**Request for Direction Report  
Zoning By-law Amendment Application  
David Dunlap Circle, Block A, Plan 66M-2365 (formerly  
part of 39 Green Belt Drive)**

<b>Date:</b>	August 19, 2011
<b>To:</b>	North York Community Council
<b>From:</b>	Director, Community Planning, North York District
<b>Wards:</b>	Ward 34 – Don Valley East
<b>Reference Number:</b>	10 163304 NNY 34 OZ & 10 163295 NNY 34 SA

Staff report for action – Direction Report – David Dunlap Circle, Block A, Plan 66M-2365 (formerly part of 39 Green Belt Drive)

**Attachment 1: Site Plan**

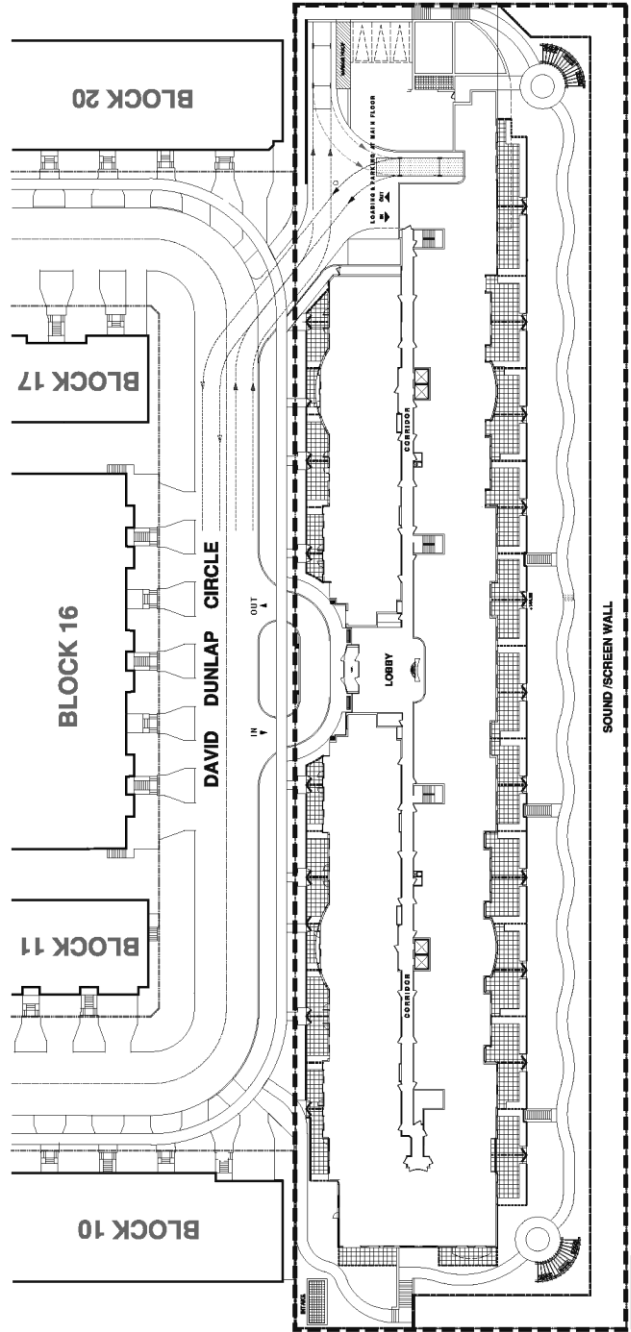
- a) The driveway access must be aligned at 90 degrees to the road;
- b) A minimum 3.0 m between the proposed driveway access and the existing driveway for 212 David Dunlap Circle must be shown on revised plans;
- c) There are five barrier free visitor parking spaces on the P2 level which were not included in the statistics. This must be clarified;
- d) A continuous dropped curb must be illustrated at the driveway accesses; and
- e) For the applicant's information, the underground ramp designs must satisfy all of the following criteria:
  - The maximum slope of a covered or heated ramp shall be 15 percent;
  - The maximum slope of an outdoor unheated ramp shall be 10 percent;

- f) The proposed location of the loading space (moving/delivery) does not have direct access to loading corridors. The applicant must clarify how on-site loading operations will occur;

- g) The applicant must revise the parking level plans as there are numerous parking spaces (regular, tandem and barrier free spaces) that do not meet minimum dimensions of 2.6 x 5.6 m or 3.65 x 5.6 m (for barrier free spaces). A regular or tandem parking space that is obstructed must be increased by 0.3 m for each side of the parking space which is obstructed;

- h) The applicant has distributed visitor parking spaces at different locations of all underground parking levels. The applicant must provide rationale for this approach; and

## Attachment 2: Concept Landscape Plan

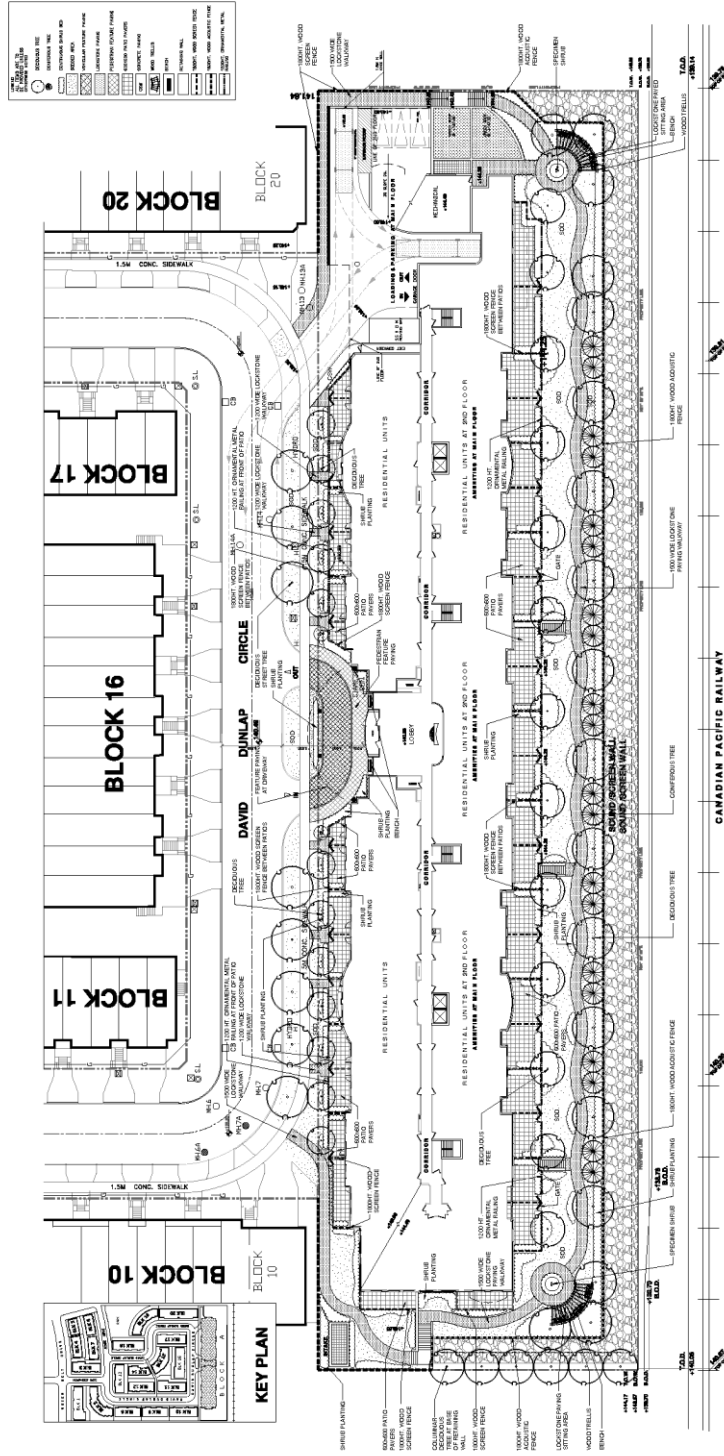
3. Submit revised landscape plans which includes but is not limited to details of the following; the location, size, number and species of all plantings on site and on adjacent road allowance, soil depths; paving materials of all sidewalks, walkways, vehicular areas and other hard surface areas; the location, height and material of all fences, screen walls, retaining walls, recreational facilities, benches; the location, height and type of lighting; proposed utilities, transformers, gas regulators, air intakes/exhausts, garage access stairs, etc., existing and proposed elevations at property lines, driveways and building entrances.

12. A revised landscape plan shall be submitted which shows a row of within the David Dunlap Circle road allowance planted at a minimum spacing of 8 to 10 metres. A combination of Japanese katsura trees, Chinkapin oak trees or Firehall maple trees (*Acer X Freemanii* "Firehall" is recommended.
13. A tree planting security deposit in the amount of **\$583.00** per tree is required for the tree planting within the road allowance. These costs are subject to change.

**Attachment 3: Ground Floor Plan**

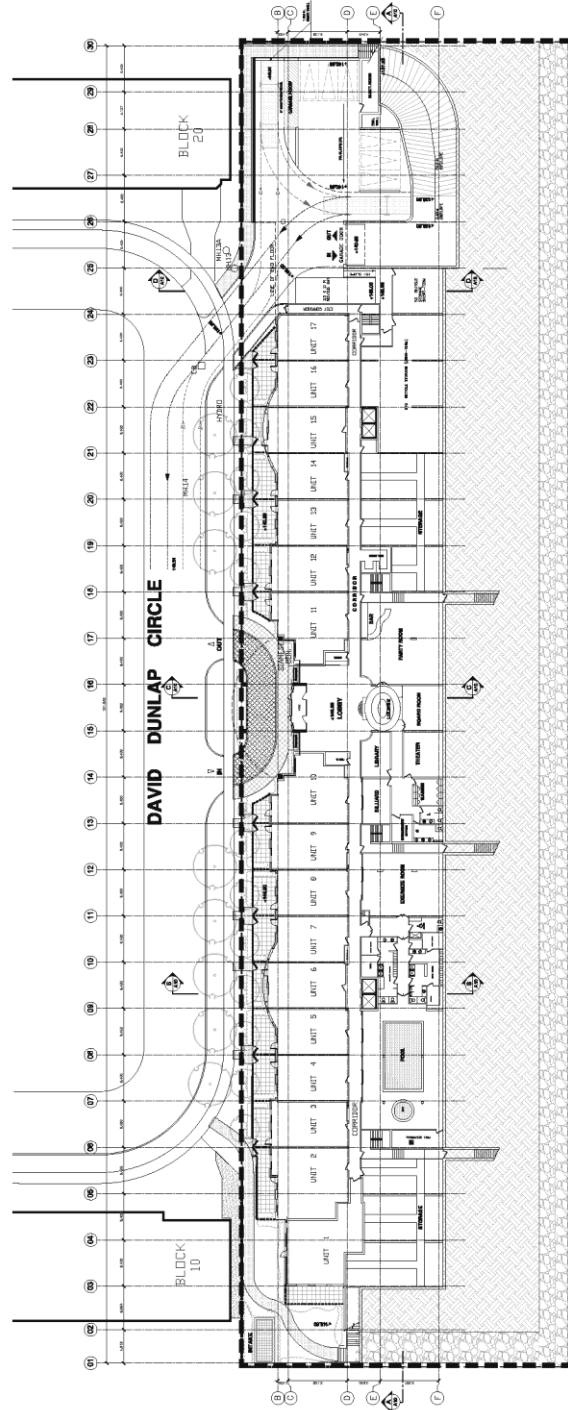
The increase of 158 units from 192 to 350 would be accommodated within the approved gross floor area therefore the proposal complies with the maximum density permission. The increase is achieved by proposing a wider range of smaller units than originally contemplated and providing a full residential 9<sup>th</sup> storey. The indoor recreational amenity space currently allowed above the 8<sup>th</sup> floor (max. 30%) is now proposed on the ground floor on the south side of the building (see Attachment 3).

**Attachment 4: Elevations**

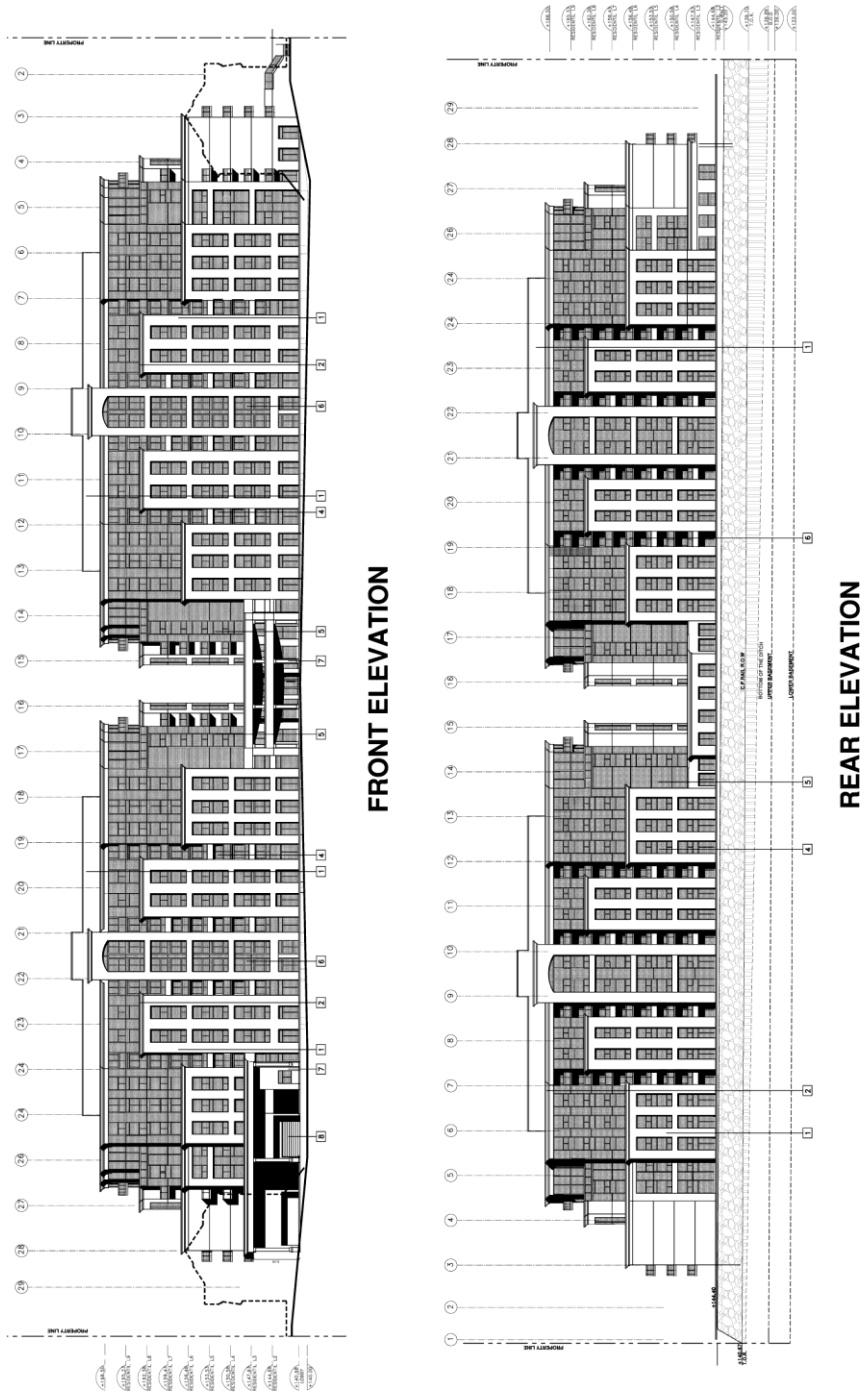
The building is designed with two 9-storey wings connected by a 2-storey central element that contains the entrance lobby for the overall complex (refer to Attachment 4). Grade related units with walk out patios are provided on the north side (street side) and south side of the building. The building has a gross floor area of 22,865m<sup>2</sup> (246,117) including 620m<sup>2</sup> (6,673 sq.ft.) of common indoor amenity space resulting in a density, or Floor Space Index, of 2.68. The proposed gross floor area together with the existing gross floor areas of the 210 townhouses in the subdivision is 59,076m<sup>2</sup> (635,894 sq.ft.). The proposed gross floor area is in accordance with the maximum allowed in the site specific Zoning By-law.
